Subject: **Revised Response (Revision 2) to Portion of NRC Request for Additional Information Letter No. 391 Related to Design Control Document (DCD) Revision 6 – Fuel Racks - RAI Number 9.1-144**

**Revised Response (Revision 2) to Portion of NRC Request  
for Additional Information Letter No. 391  
Related to Design Control Document (DCD) Revision 6**

**Fuel Racks**

**RAI Number 9.1-144**

**Figure 1-1. Layout of Fuel Support Racks and Base Plates**

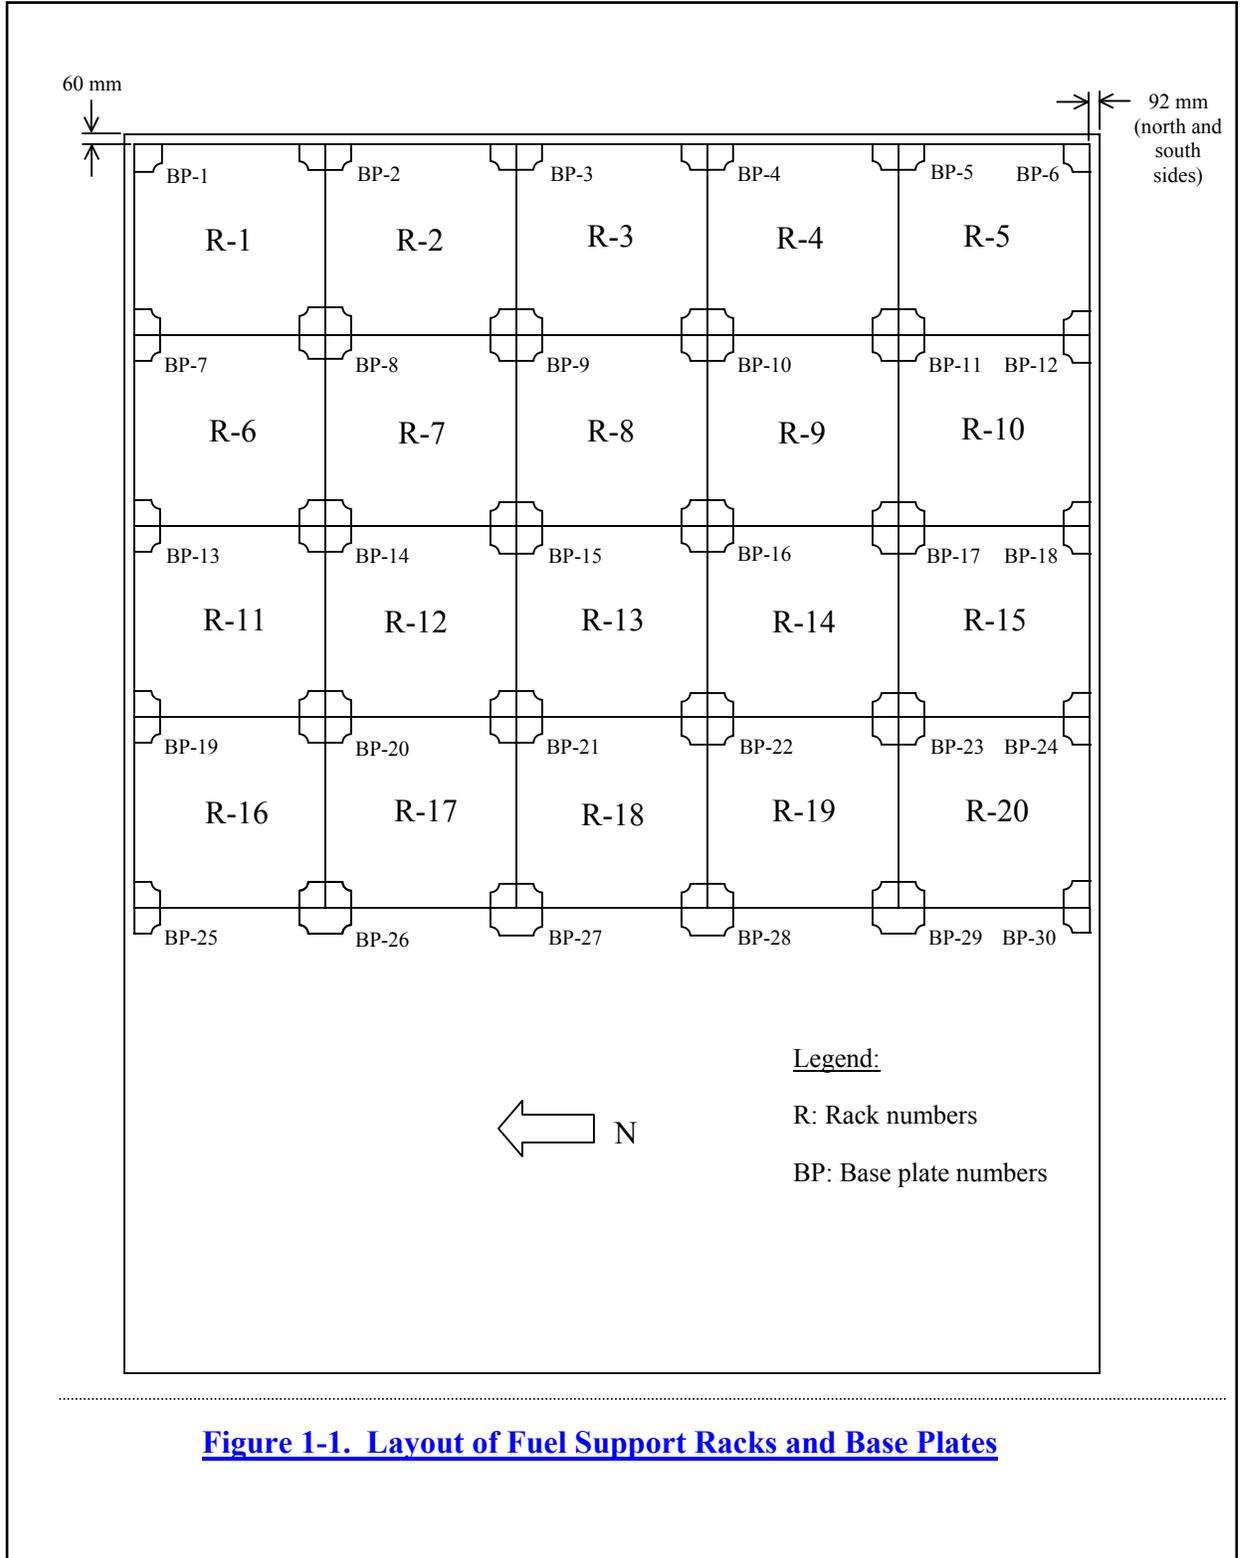
- 1) the applicant provide justifications for not including the  $T_a$  in ASME Service Level D load combination, and demonstrate the racks will not impact the pool wall liners during an SSE event concurrent with  $T_a$ ;*
- 2) the applicant demonstrate the effect of thermal gradient based on the Service Level D load combination will not impact the functionality of the racks by following the guidance provided in Section 1.4 (the 3rd sentence of the 1st paragraph) of Appendix D to SRP 3.8.4.*
- 3) Provide clarification of terms used in Section 1.6.5.1 such as R-16, BP-26, etc., which can be best illustrated by providing a schematic plan view of the layout of racks in the pool including the gaps with the pool walls.*

In the N-S direction, the minimum clearance to the fuel pool wall has increased from 42 mm to 92 mm. This increase can be accommodated since the tolerance in the N-S pool dimension has been decreased by 100 mm (the minus tolerance was changed from 300 mm to 200 mm per Table 2.16.7-1 in Tier 1 of DCD Revision 6), thus increasing the fuel pool dimension in the N-S direction by 100 mm. Since the pool dimensions started with a relatively large tolerance, tightening the tolerance will not be an issue in view of the accurate alignment equipment that is commercially available.

At the east wall, the racks will be placed with a minimum gap of 60 mm to accommodate seismic and thermal expansion.

- 3) LTR NEDC-33373P Figure 1-1 is added to provide clarification of terms used and illustrate by providing a schematic plan view of the rack and base plates in the pool including the gaps with the pool walls as shown in the attached markup.
